Access Compliance Report

Public Rights-of-Way

| Intersection ID: 48460 | Main Street: TARPWAY_RD | Cross Street: PANGLEMONT_DR | Location: SE |
| ADA ID: E079C2905022 | Ramp Type: PerpDiag | Initial Pass/Fail: Fail | Overall Compliance: No |

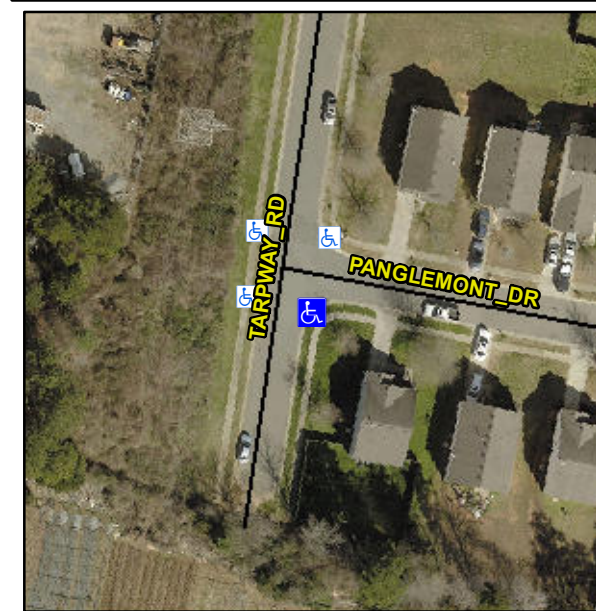
Not Found, R304.5.1, R304.2.2

| Compliance | Description | Data | Compliance | Description | Data |
|------------|-----------------------|------|------------|-----------------------------|------|
| N/A | Ramp Length (in) | 47.5 | No | Ramp Slope (%) | 8.5 |
| No | Ramp Width (in) | 46.0 | Yes | Ramp XSlope (%) | 0.0 |

Remove & Replace Curb Ramp With Two New Directional Ramps or Equivalent.
